SUBJECT: IN THE MATTER OF 238 NUCLEAR ISLAND
GENERAL ELECTRIC STANDARD SAFETY ANALYSIS REPORT (GESSAR II);
DOCKET NO. STN 50-447

Attached please find draft responses to the Commission's August 25, 1982 request for additional information on GESSAR II. These responses, provided in Attachment Nos. 1 through 8, reflect the NRC/GE information exchange meetings held in Bethesda from October 7, 1982 through October 26, 1982.

ATTACHMENT NO. 1

DRAFT RESPONSES TO
STRUCTURAL ENGINEERING BRANCH
QUESTIONS

Fig. 1 - COMPARISON OF RESPONSE SPECTRUM OF FREE-FIELD GROUND SURFACE MOTION WITH NRC DESIGN SPECTRUM

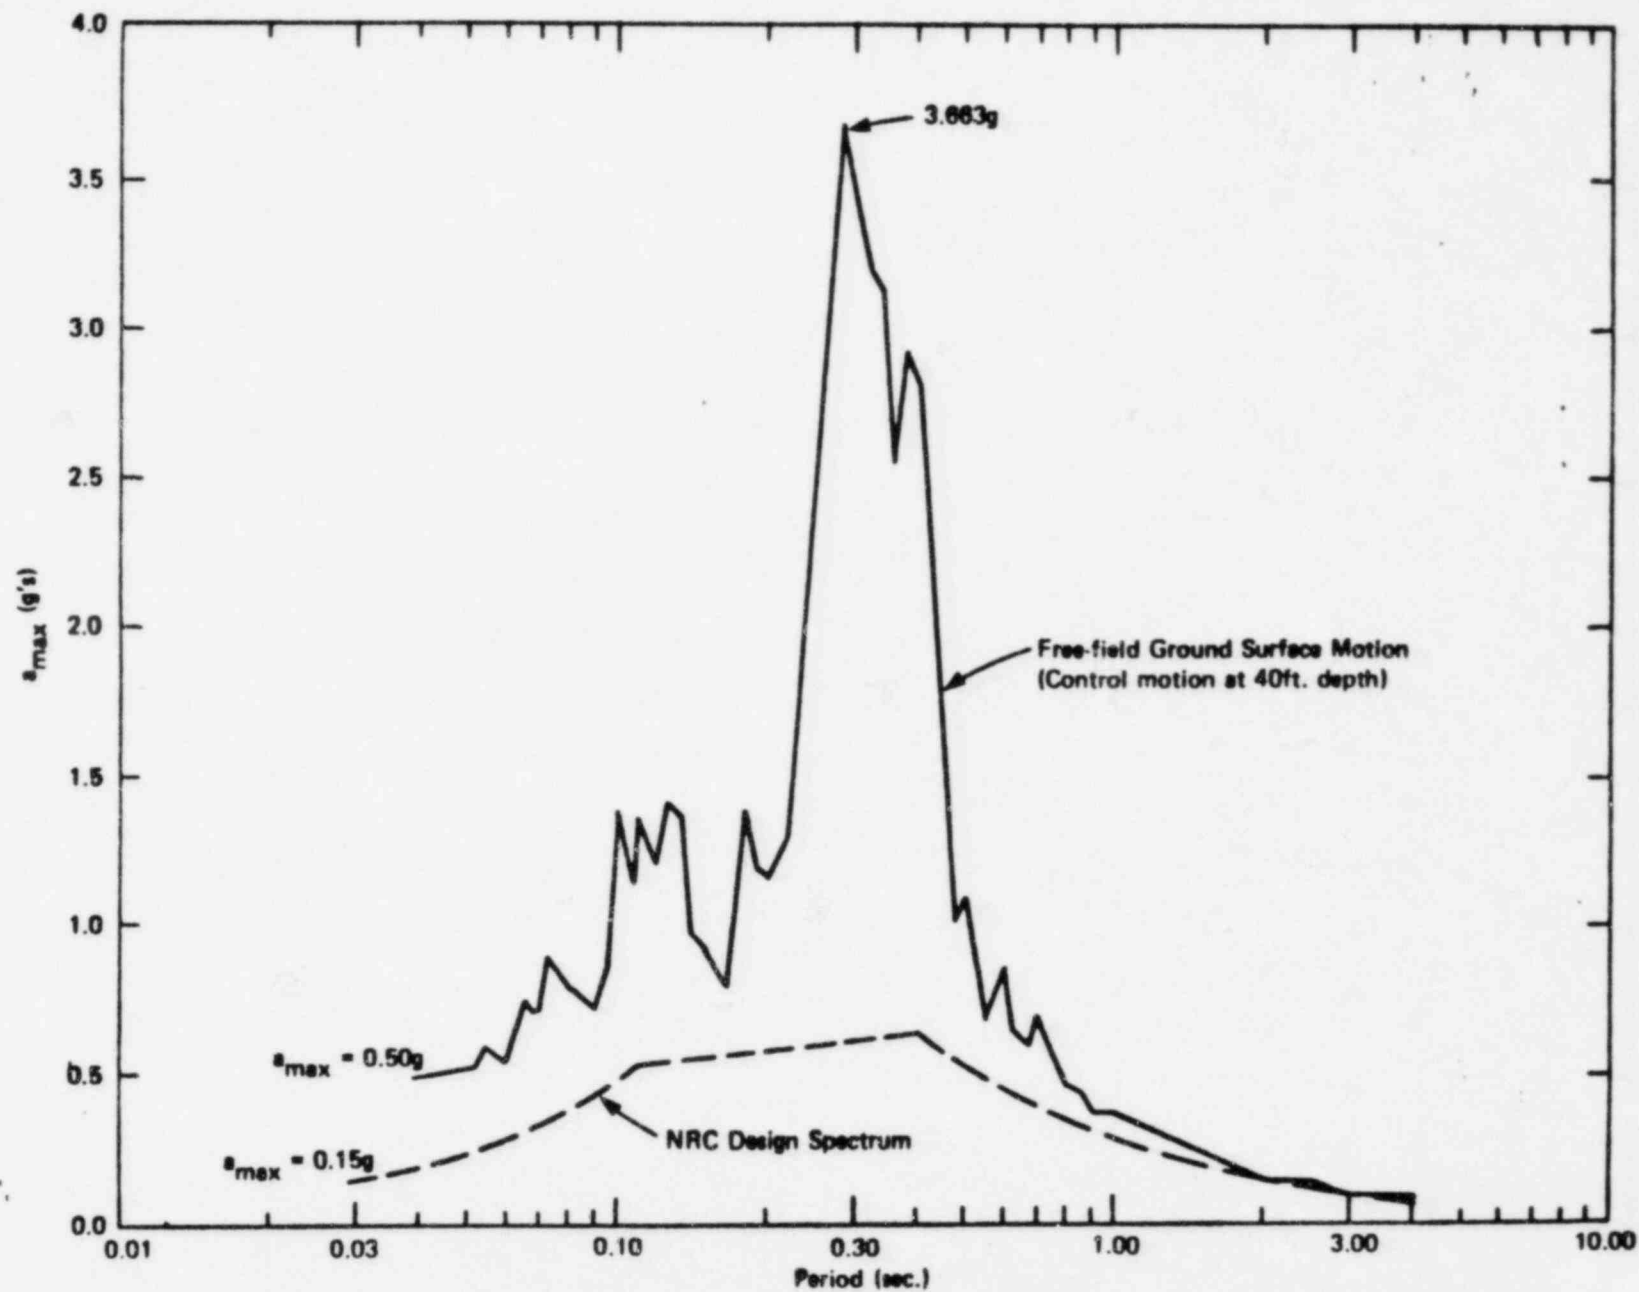
Question 220.44 (3A.5.2, Fig. 3A-18)

If a design response spectrum and associated control motion defined on the basis of ground surface recordings is placed at depth in a soil mass, then unrealistic motions will be calculated at other points in the mass. The motions calculated at the ground surface will be greatly amplified, particularly when the input motion at depth has a broad band response spectrum such as RG 1.60. A typical result of placing the design control motion at a depth of 40 feet is shown in Figure 1. The design peak acceleration of 0.15 g is amplified to 0.50 g at the ground surface, or more than three times the design basis. The response spectrum amplification is even greater at some frequencies, so that the resulting response spectrum at ground surface is completely inconsistent with the design basis. For the above two reasons, several recent studies have strongly recommended that the control motion be specified at the ground surface in the free field. Among these studies are: the ad hoc committee report on SSI published by ASCE and the report by D'Appolonia (NUREG/CR693) completed for the NRC.

The design for GESSAR II incorporates the envelope of responses calculated for a wide range of subsurface soil profiles. Figure 3A-22 of GESSAR II (Figure 2 attached) shows the computed response spectra at the foundation level in the free field. The design response spectrum (RG 1.60 anchored to the OBE peak acceleration of 0.15 g) has been added to Figure 2. The current Standard Review Plan (SRP) requires that the design response spectrum be enveloped at the free field foundation level. It can be seen in Figure 2 that the computed response spectra essentially envelope the design response spectrum, indicating that the GESSAR II analyses essentially conform to the SRP.

Figure 8.3-2. Nuclear Island 6900 Volt Single Line Buses E & F

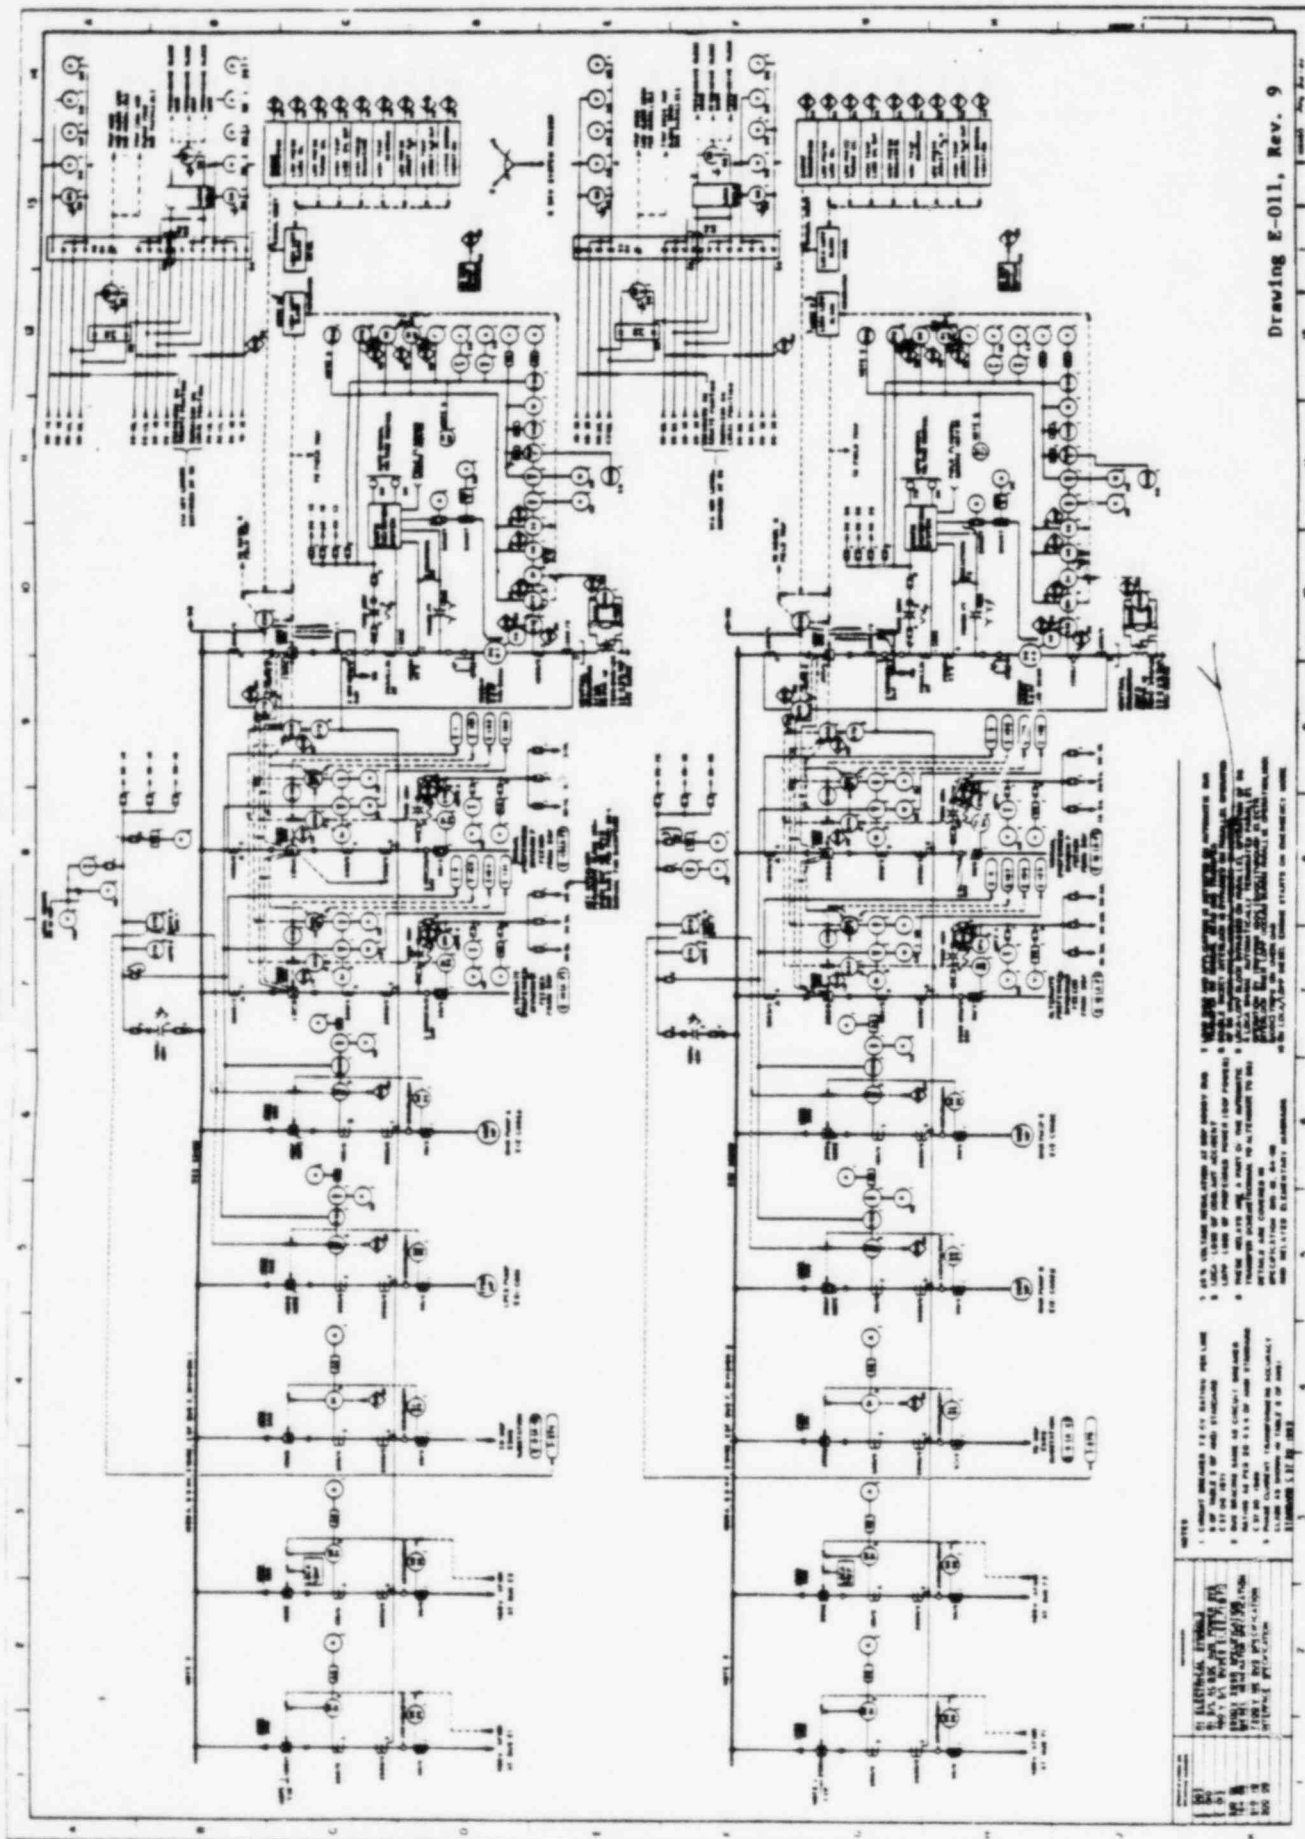
Explain note 8 of Figure 8.3-2 in your FSAR, particularly the phrase
"for BUS E Normal Feeder Backfeed."

Note 8 of fig 8.3.-2 will be revised to delete "or for Bus E NORMAL Feeder Backfeed".

QUESTION 430.61

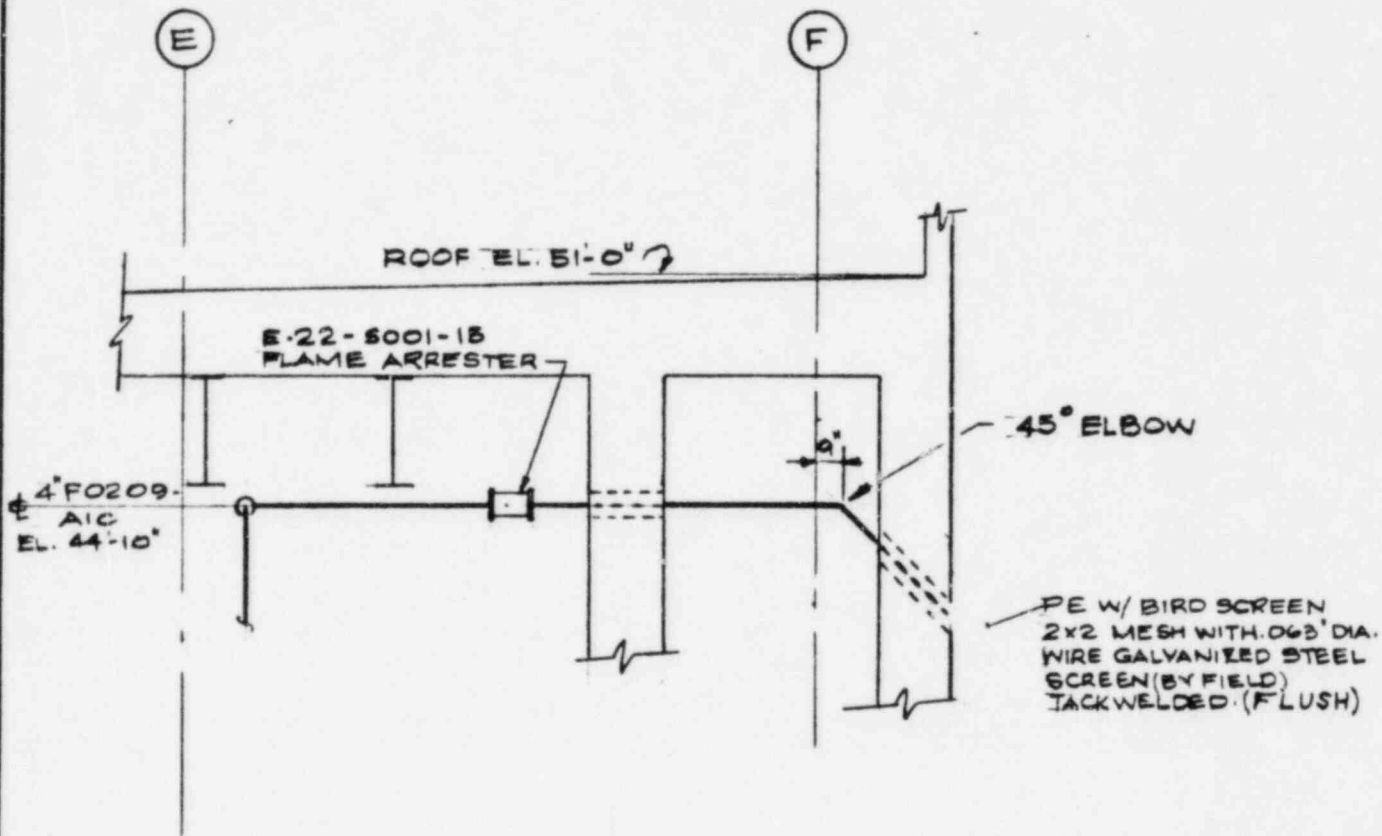
You show on Figures 9.5-10 and 9.5-11 of your FSAR, the day tank vents terminating somewhat outside the diesel-generator room. However, it is not clear from Figures 9.5-10 and 9.5-11 nor from Figures 1.2-18 through 1.2-22 of your FSAR, exactly where the Divisions 1, 2, and 3 day tank vents terminate. Accordingly, provide additional information on these vents. Show vent the terminations on appropriate views in Figures 1.2-18 through 1.22 of your FSAR and provide details of the terminations which show that they are protected from tornados, floods and the effects of severe weather conditions.

Figure 9.5-12. Division 1 and 2 Diesel-Generator Jacket Water System PSI Diagram

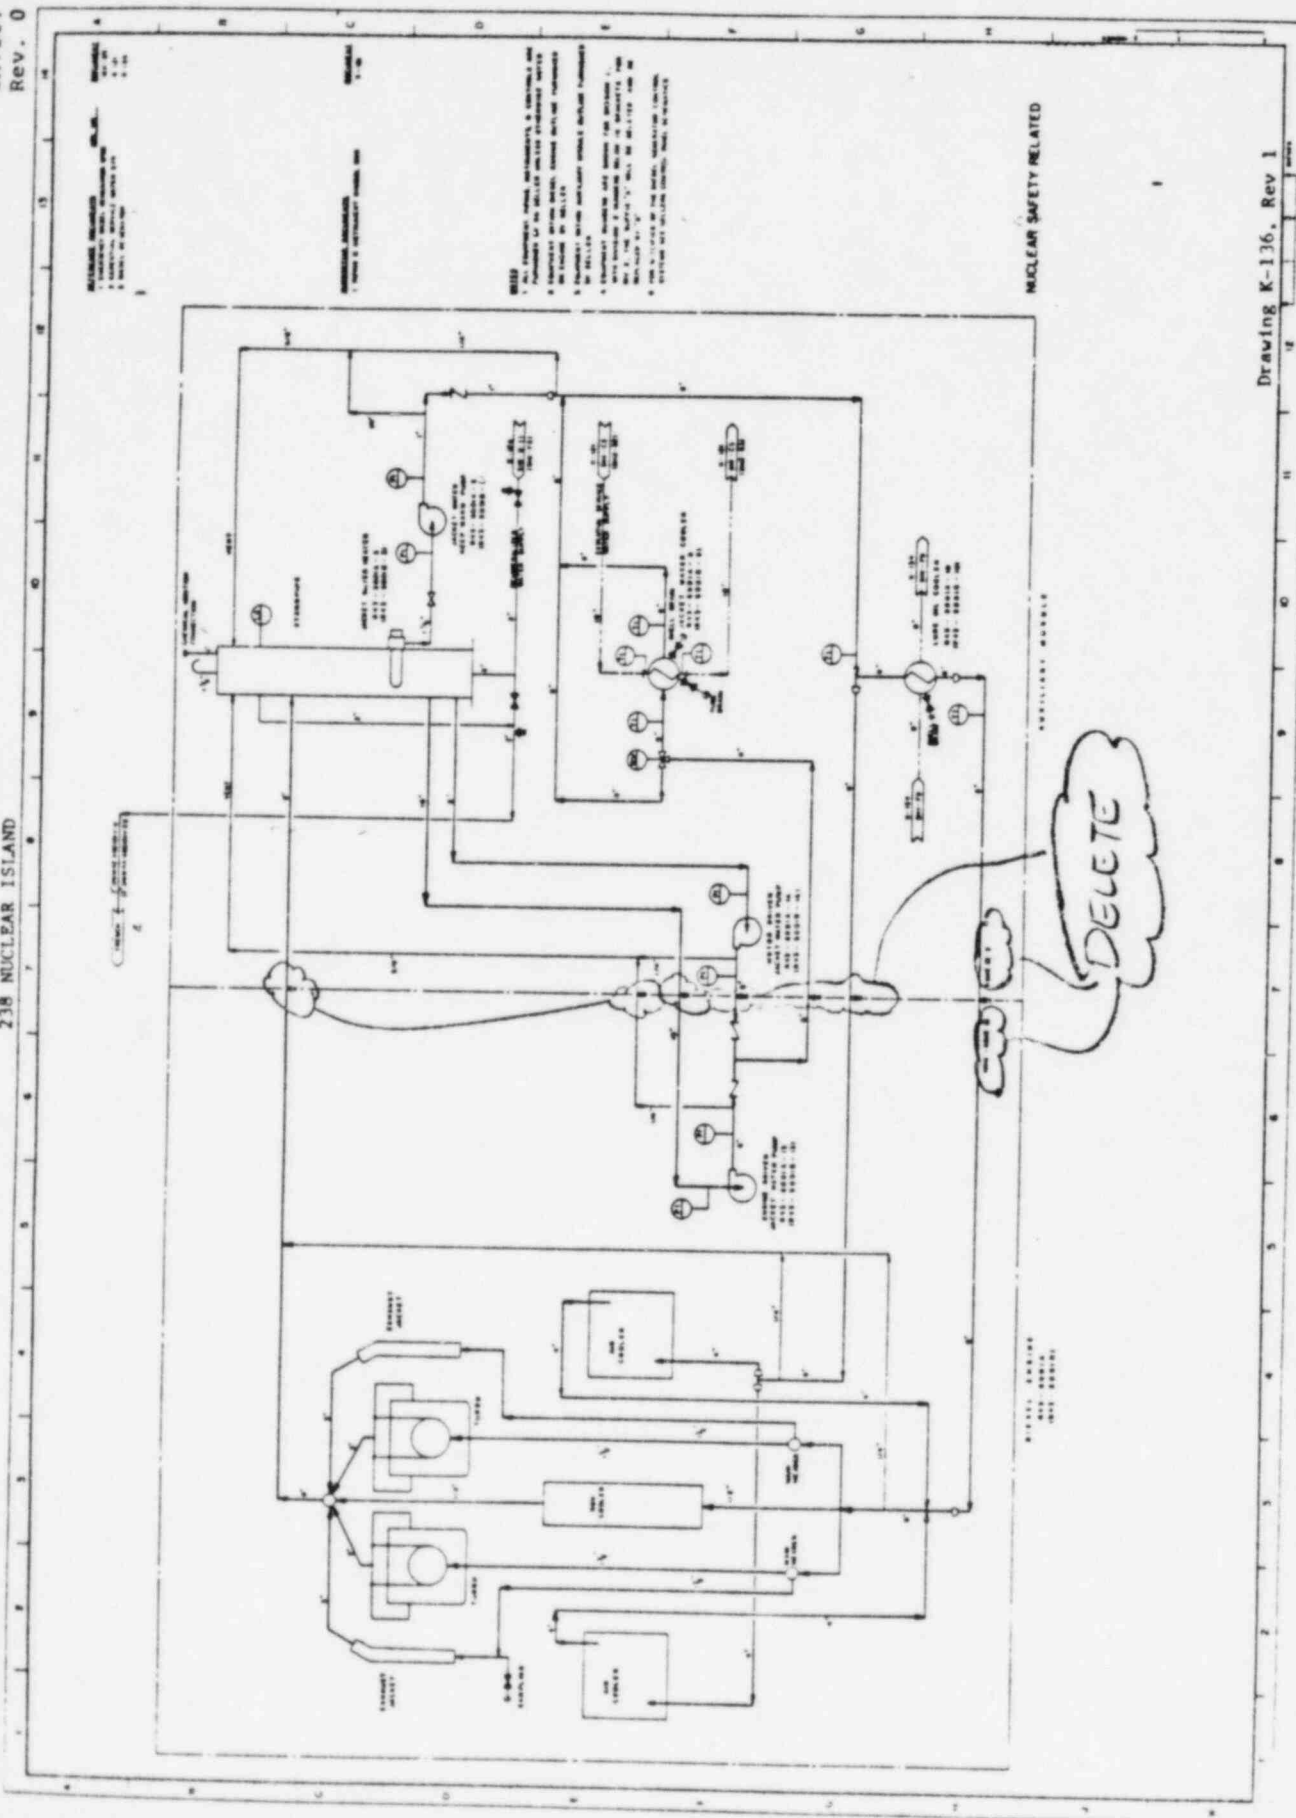
430.64 (9.5.4) (9.5.5) (9.5.6) (9.5.7) (9.5.8) - You state in the text and in Table 3.2-1 of your FSAR that the components and piping systems for the diesel-generator auxiliaries (e.g., the fuel oil cooling water, lubrication, air starting, and intake and combustion systems) are mounted on auxiliary skids which are designed to seismic Category I requirements and are built to ASME Section III, Class 3 quality standards. You also state that engine-mounted components and piping are designed and manufactured to DEMA standards and are designed to seismic Category I requirements. However, this is not in accordance with our position in Regulatory Guide 1.26 in which we state that all the diesel-generator auxiliary systems should be designed to ASME Section III, Class 3 or Quality Group D standards. Provide the industry standards which you will use in the design, manufacture, and inspection of the engine mounted piping and components. Show on the appropriate P&I diagrams where the Quality Group Classification changes from Quality Group C.

For the diesel engine cooling water system Figure 9.5-12 will be revised to delete the ASME III-3 & non-ASME III interface as shown on the attached marked-up page 9.5-77/9.5-78. Black, heavy arrows will be deleted.

Figure 9.5-10. Division 1 and 2 Diesel Fuel Transfer, Intake and Exhaust System P&I Diagram

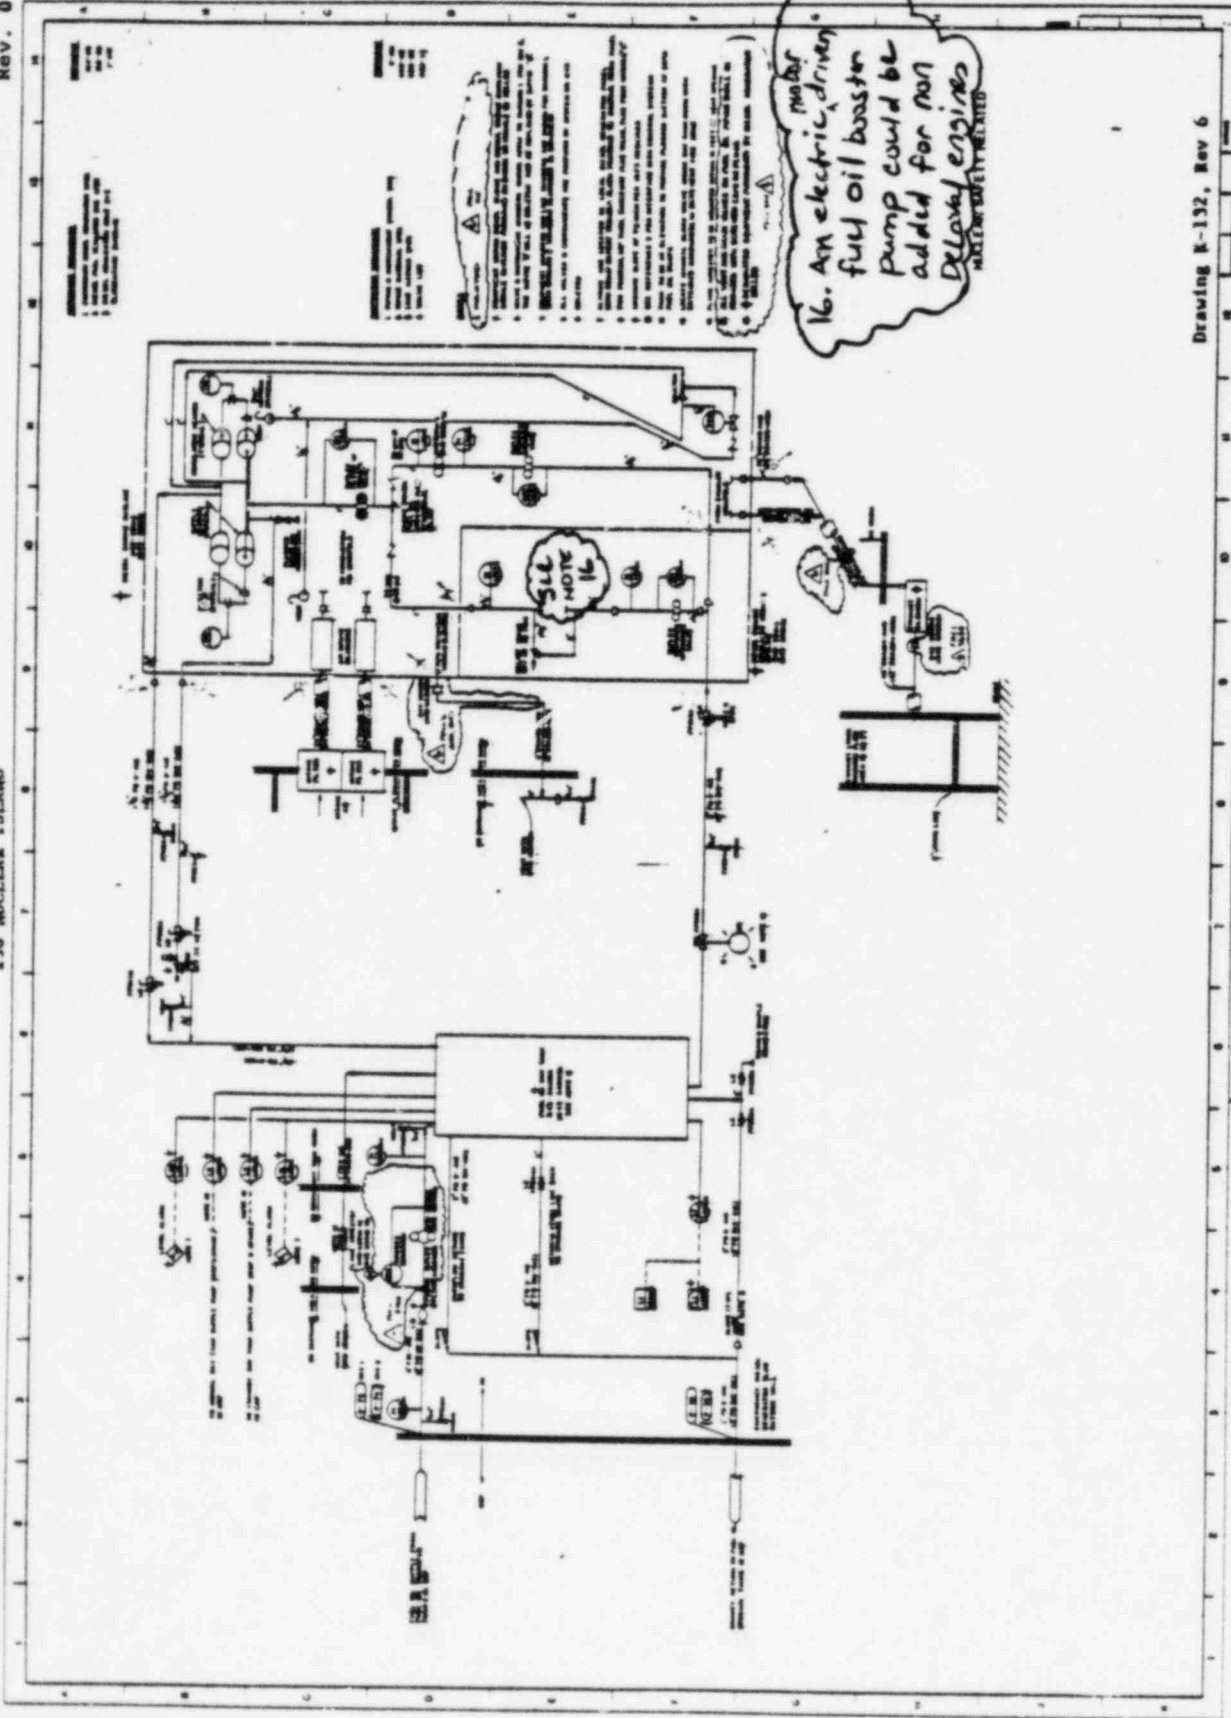
- a. Revise Figure 9.5-10 of your FSAR to show the interface between the fuel oil system piping and the diesel engine mounted piping/components. Provide quality group classifications for all system piping and components and, if applicable, identify all changes in piping/component quality group classifications at the interface.

Note 16 will be added in GESSAR Figures 9.5-10 - "an electric motor driven fuel oil booster pump could be added for non-DeLaval engines", as shown in the attached p. 9.5-73/9.5-74.
